Application Note AN-1115

IRS442(6,7,8) and IR442(6,7,8) Comparison

Figures

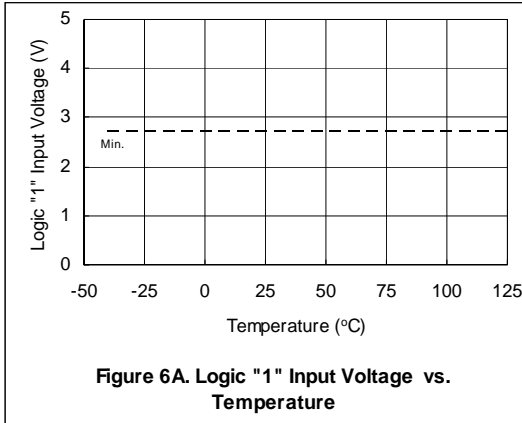
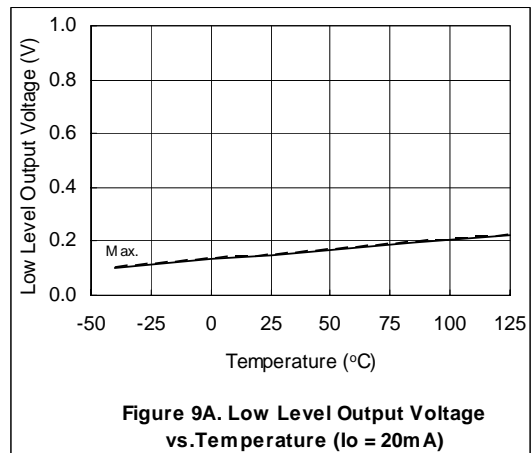
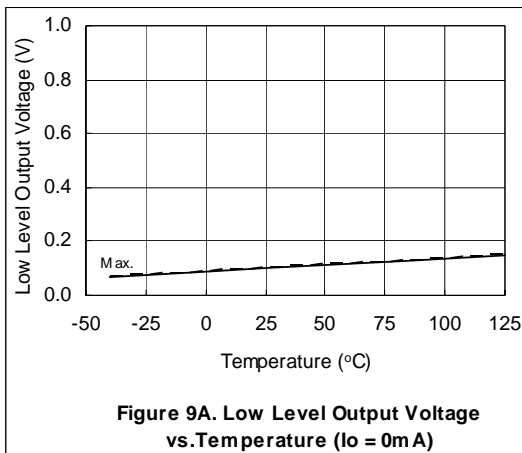
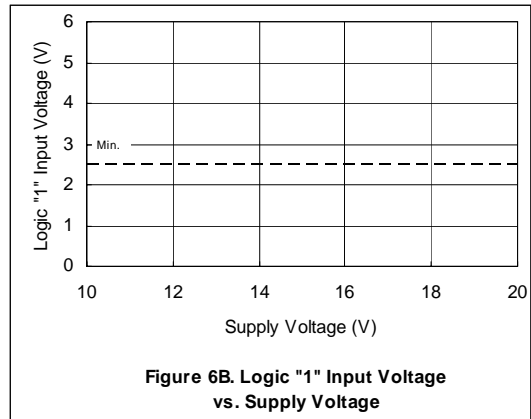
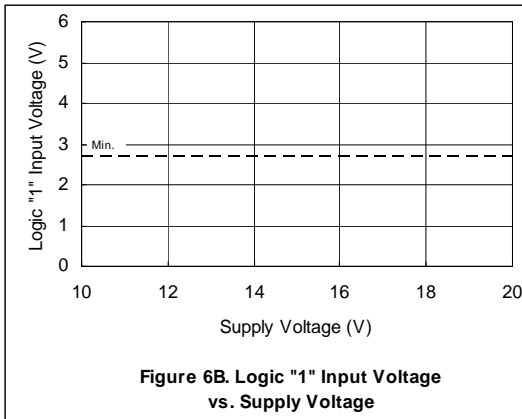
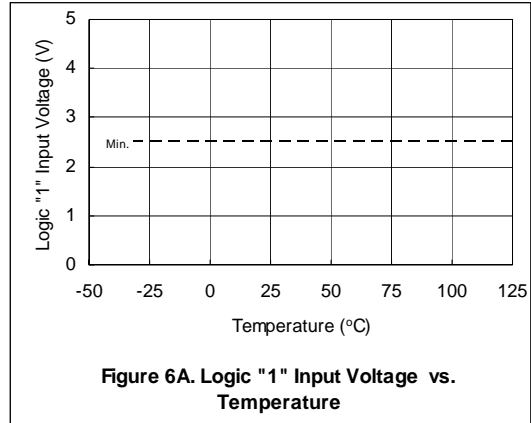
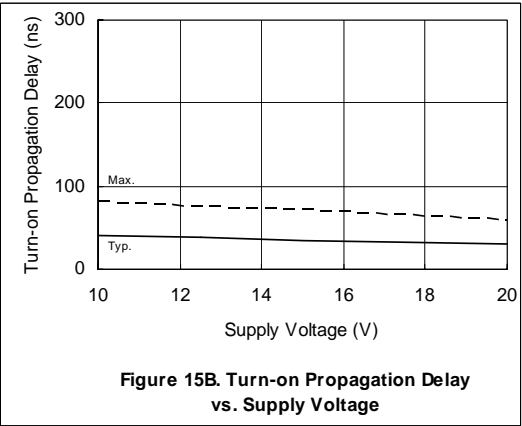
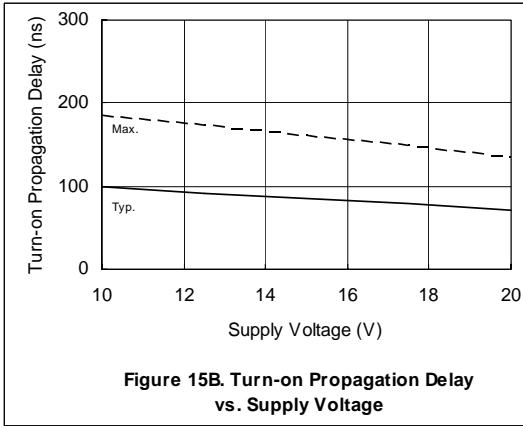
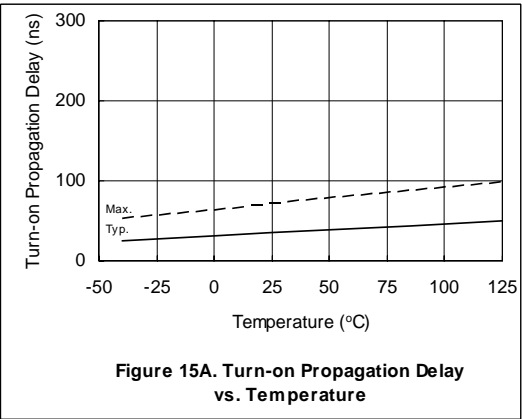
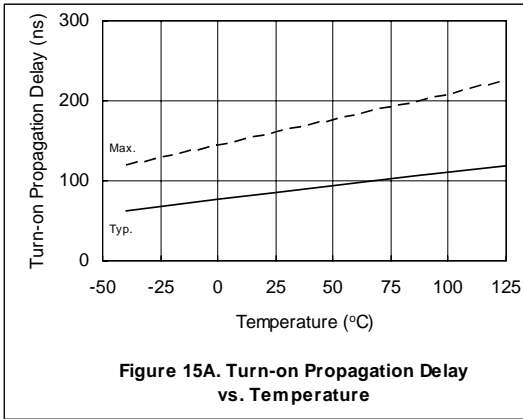
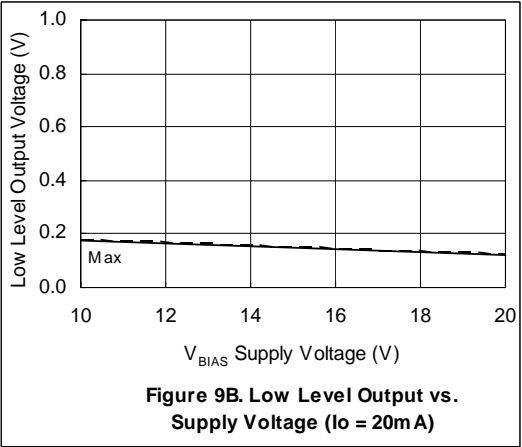
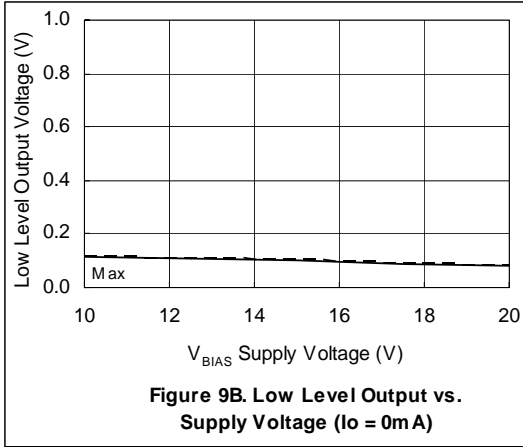
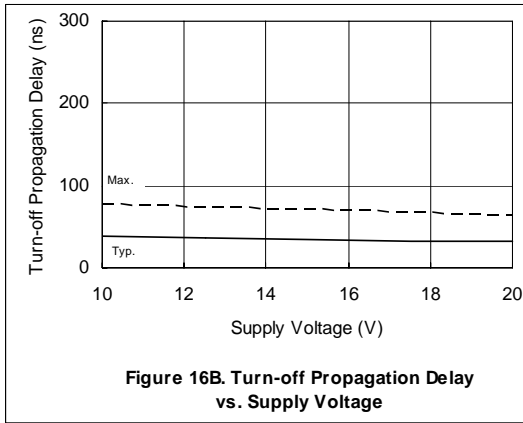
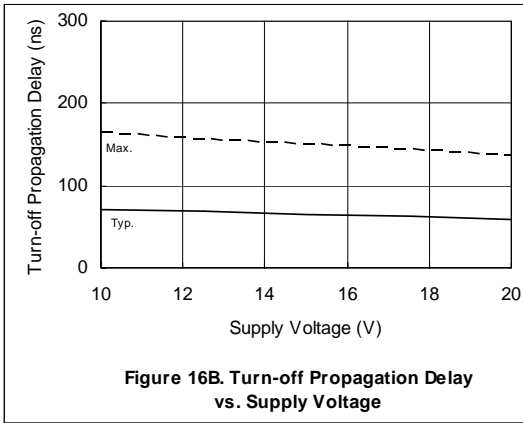
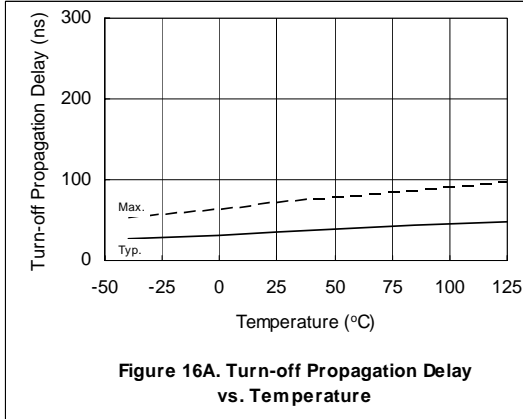
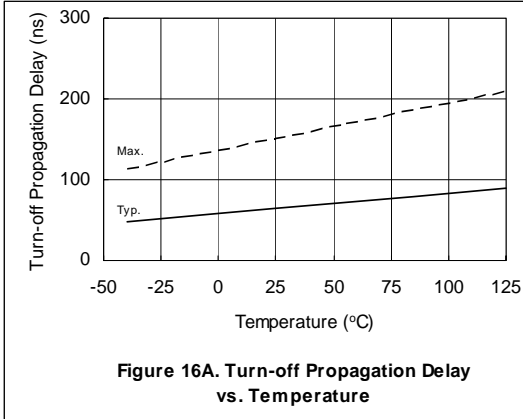
This figures shown in this section compare figures shown in the IR442(6,7,8) (left column) and IRS442(6,7,8) (right column) datasheets. Illustrations that have not changed between the two datasheets have not been included in this section.
